This Service Information bulletin supersedes SI B33 03 14 **dated April 2014.**

NEW **Service Action/Delivery Stop: Rear Shock Absorber Guide Support**

F15 (X5)

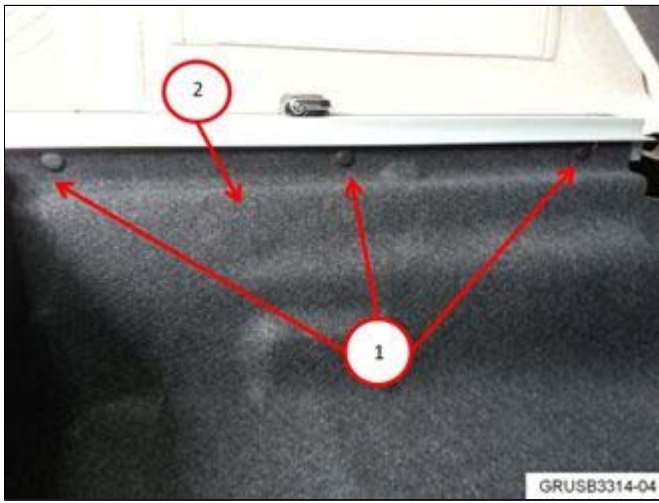
Check **both** guide supports and replace if the wrong part number parts are found.

Correct part number: 6 851 881

Incorrect part number: 6 867 864

If the incorrect guide support is installed, replace it per Repair Instruction 33 52 161. See the attachment REP3352161.
